**PCN: V14-005-00475504-OB**

## Product Change Notice

Change Type #1: Alternate LED supplier

Change Type #2: Alternative supplier for stacked PCB

Figure 1: Internal layout comparison between current LED and new LED.

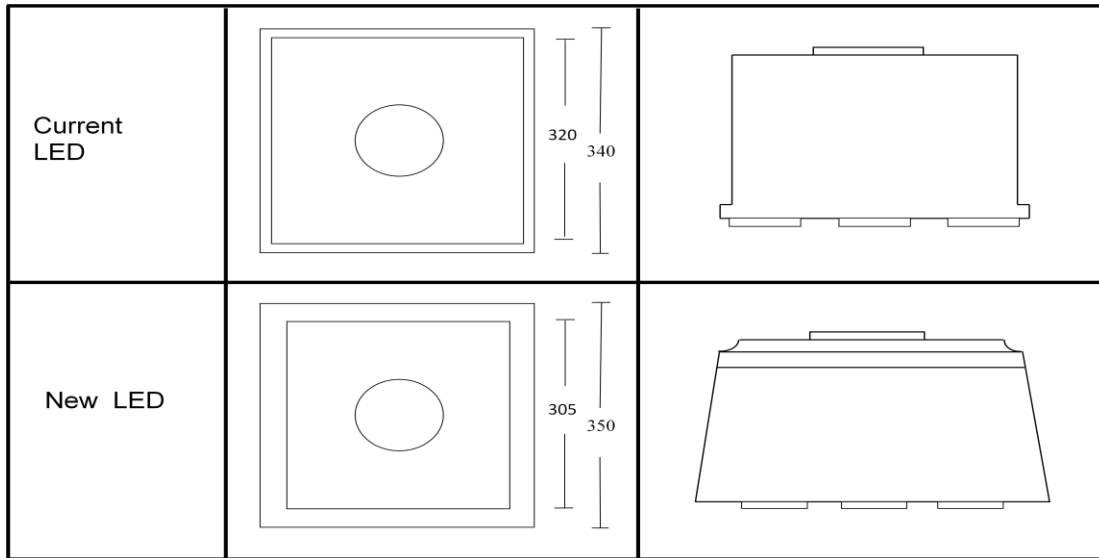
The photos below show the internal layout of the product for both LEDs. The slant wall of new LED is due to different wafer fabrication process, and doesn't affect electrical performance of the product. There's no change to the dimensions of the package.

The change does not affect the performance and reliability of the package. There is no change to the datasheet.

Figure 1: Comparison of the current and new PCBs.

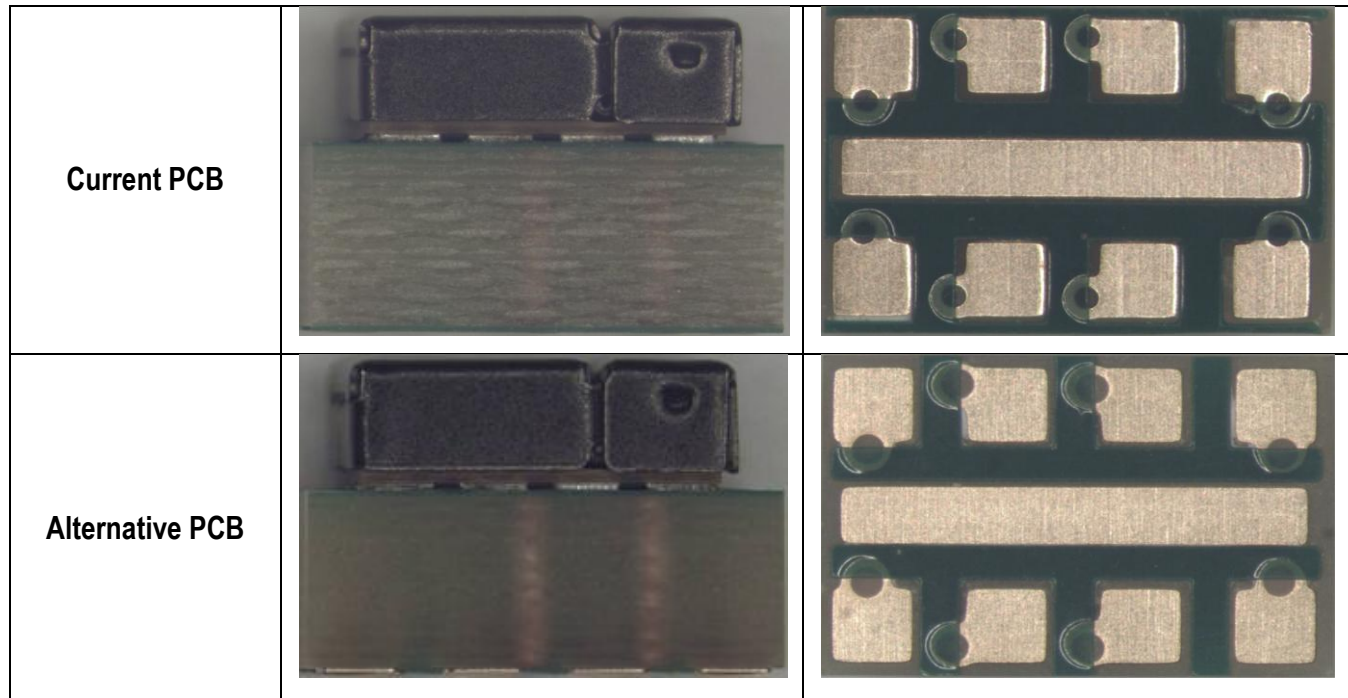
The photos below shows the exterior package of the current devices produced, and compared to the new changed part.

The change does not affect the size and dimension of the package. There is no change to the datasheet.
